**Public Hearing for Southport West Replat 5—
Preliminary PUD, Preliminary Plat, & Final Plat**

RECOMMENDATION REPORT

CASE NUMBER: 2014-PUD-04; 2014-SUB-06 FOR HEARING OF: July 17, 2014
Report Prepared on: July 10, 2014

RE: Preliminary PUD, Preliminary Plat, Final Plat -Initial Review
Southport West Replat Five
City Engineer Review Comments

PLANNED UNIT DEVELOPMENT
EMERGENCY VEHICLE EXHIBIT

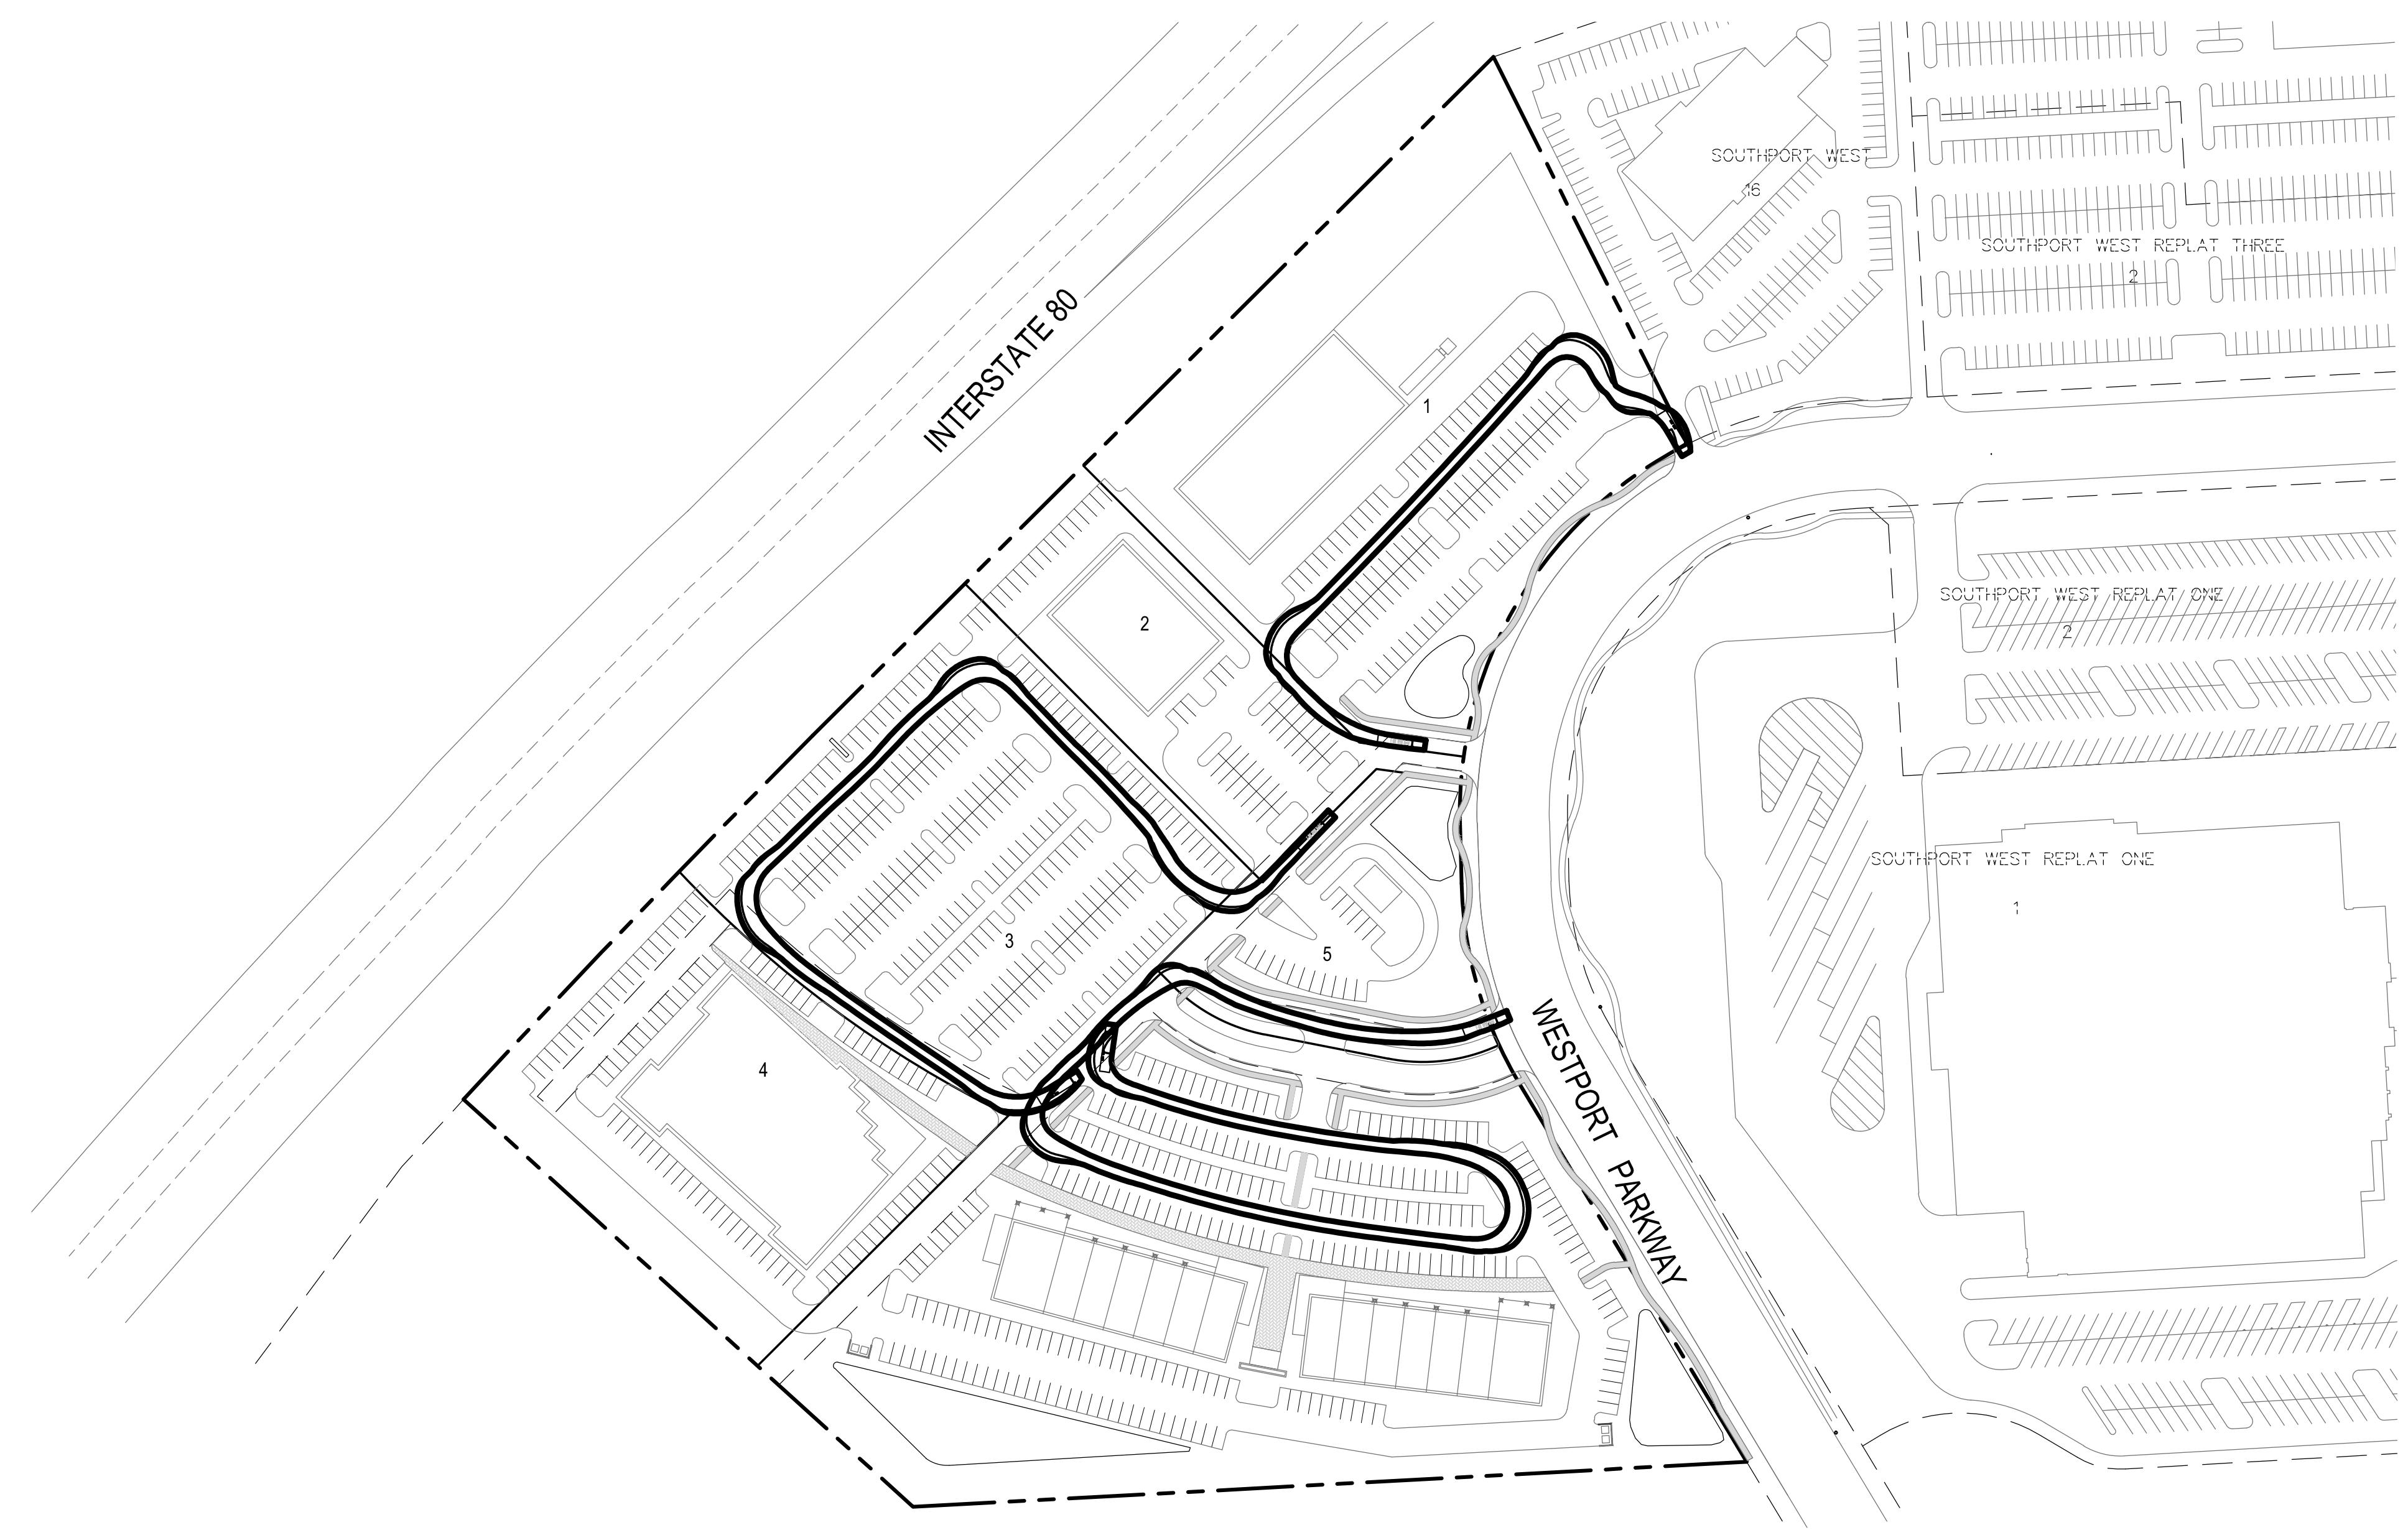
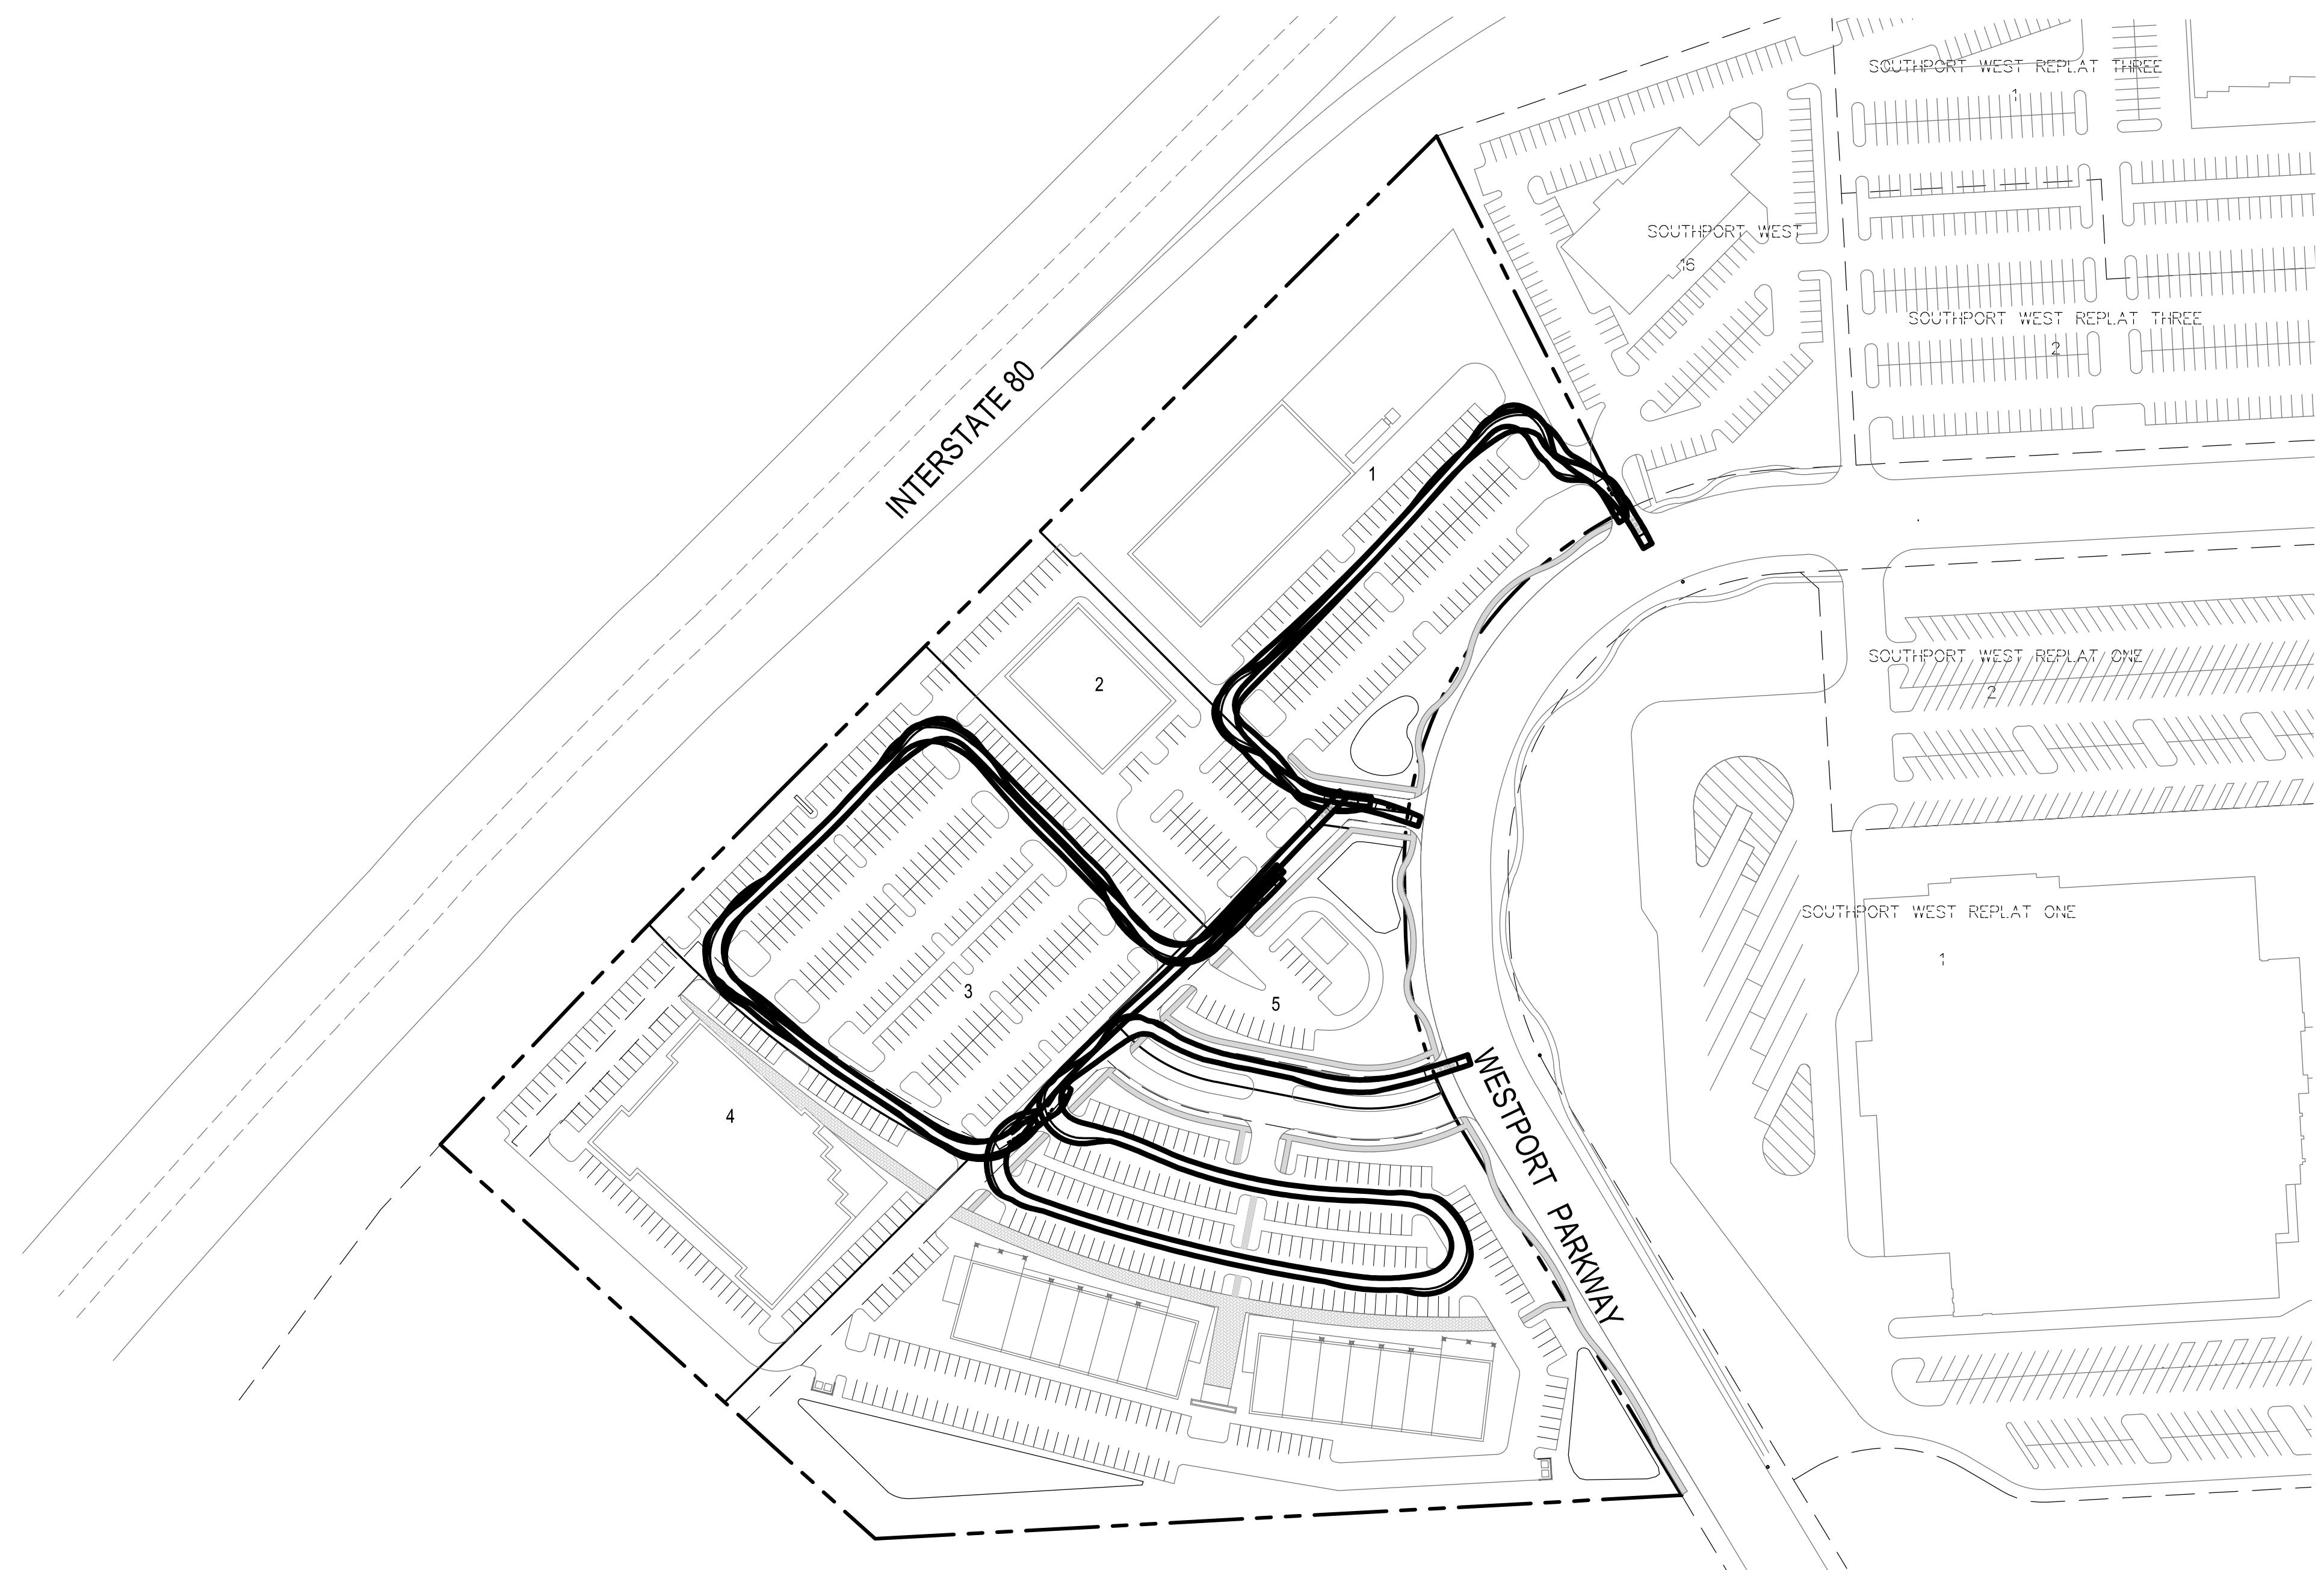
7. The Site Parking Table on the Emergency Vehicle Exhibit shows Lot 4 to be a retail use. However, I understand this building is to be used for an Assembly type use. The potential occupancy as an assembly type use needs to be indicated so that adequacy of parking for that use can be reviewed. The Site Parking Table contains a note indicating shared parking between Lots 3 and 4 but not with the remaining lots. Under that scenario, the remaining lots appear to have an abundance of parking for the uses indicated. An example is Lot 5 at a ratio of 8.65 stalls per 1,000 and Lot 1 having more stalls than would be necessary for the intended use. Ordinance No. 1013 allowed for parking in aggregate to be 4.5 stalls per 1,000 square feet. If the proposed use of Lot 4 necessitates the overall parking count, then that should be clarified and allowed with appropriate cross parking easements.

13. The Emergency Vehicle Exhibit needs to be reviewed by the Fire Marshall. The class of vehicle and/or dimensions of the vehicle used for the turning paths needs to be labeled on the plan. There may be some curb radii that need to be adjusted.

2. Fire access lanes appear to be listed as 20' in width. They are required to be a minimum of 24' wide.
3. Though the plans include apparatus turning radii, I would like to see a plan illustrating those radii as approached from all directions. It appears that though possible to negotiate some of the turns from a particular direction, it may not be possible to negotiate the same turn from the opposite direction, which is necessary.

4. Again, regarding the turning radii; many of the turns bring the apparatus extremely close to the medians. When the lanes are expanded to 24' this may eliminate the issue.

5. It appears that some of the landscaping may present problems again with the turning radii. The plans do not indicate the expected dimensions of the trees planted in the medians at the turning points. I am concerned that as the trees grow they will impede the ability of an apparatus to negotiate the necessary turns to access all of the property.
